NO.	1	RE-ALIGN CURB TO CLEAR EXISTING WELL CASING
APPROVED		REVISION
REGISTERED CIVIL ENGINEER NO.	135425	
DRAWING NO.	3344	CHECKED BY
SHEET 3 OF 6		RECOMMENDED

CITY OF SAN BERNARDINO
 DEPARTMENT OF ENGINEERING
 FORTIETH STREET
 Between Harrison Street and Mountain Avenue
 Milburg

DRAWING NO.	3344
CHECKED BY	Don
DATE	
RECOMMENDED	
SHEET	3 OF 6 SHEETS

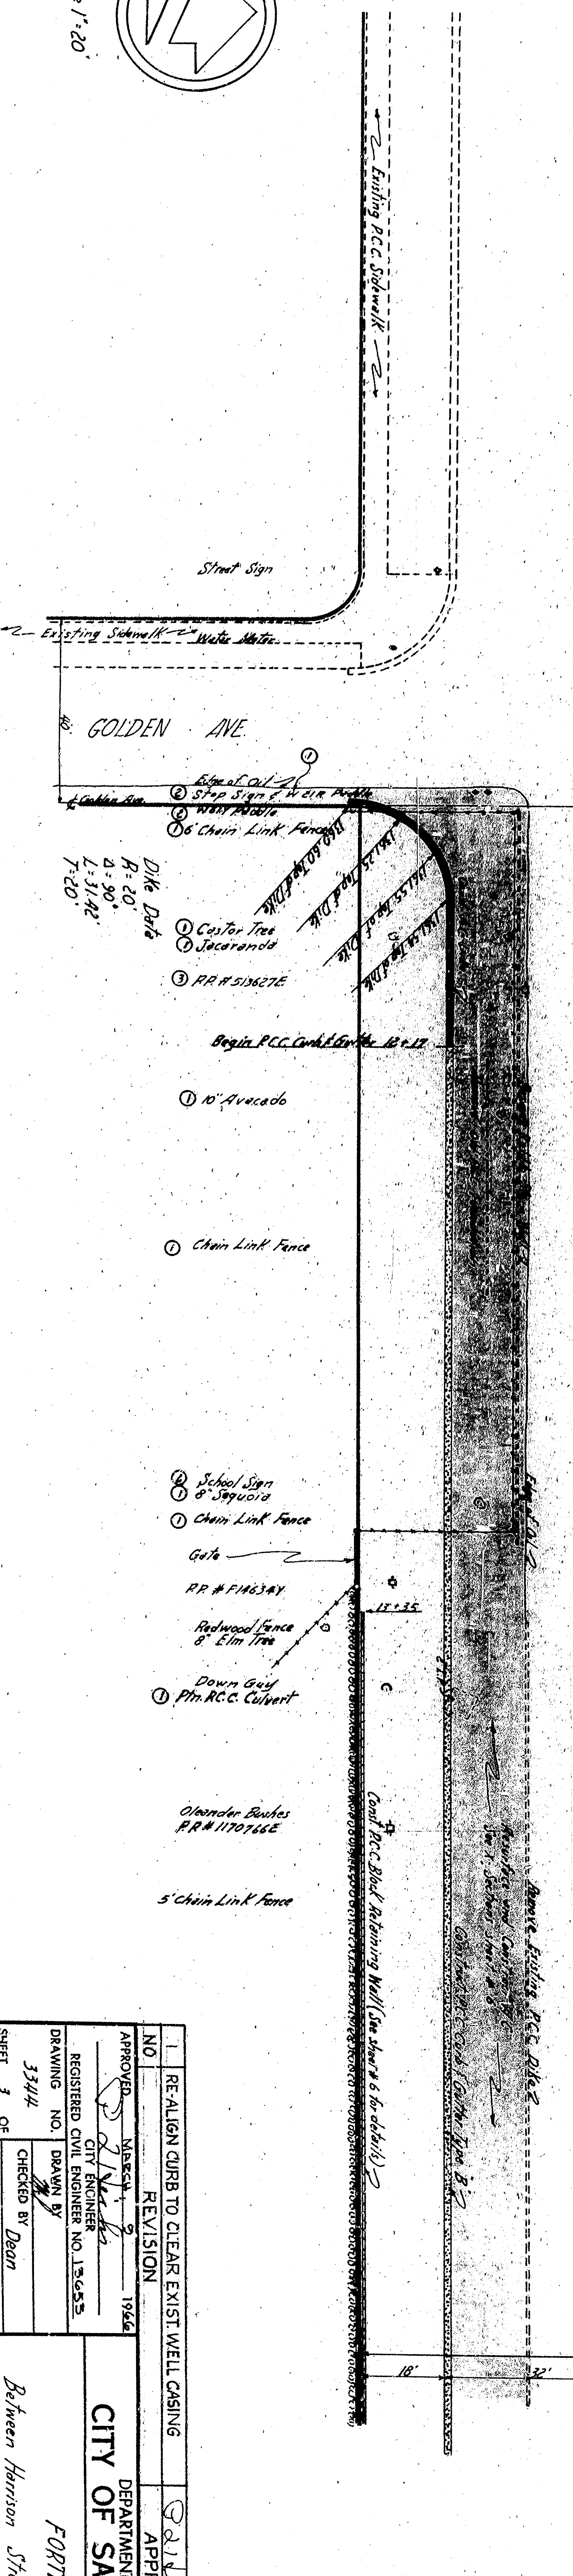
NO.	1	RE-ALIGN CURB TO CLEAR EXIST WELL CASING	APPROVED	DATE	MAY 5, 1966
REVISION	1		APPROVAL		
CITY OF SAN BERNARDINO					
DEPARTMENT OF ENGINEERING					
FORTIETH STREET					
Between Harrison Street and Mountain Avenue					
Milburg
